**DATE:** 11.21.2019  
**TO:** ProTrak  
**FROM:** Mitesh Baxi  
Traffic Engineering

■ **MAIDES PARK GYMNASIUM ADDITION [TRC Plan Review #3]**

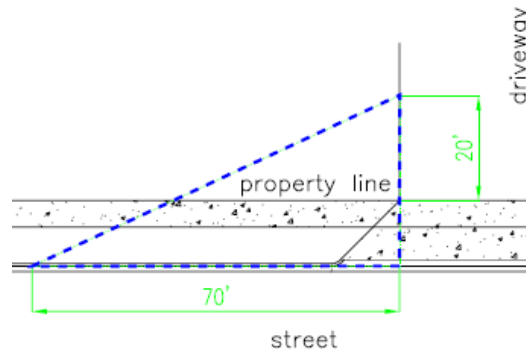
1. The City's 20'x70' sight distance triangle is not implemented correctly at the northern driveway. Please revise as per below image. [Sec.18-529(c) (3) CofW LDC] [Sec. 18-812 CofW LDC].
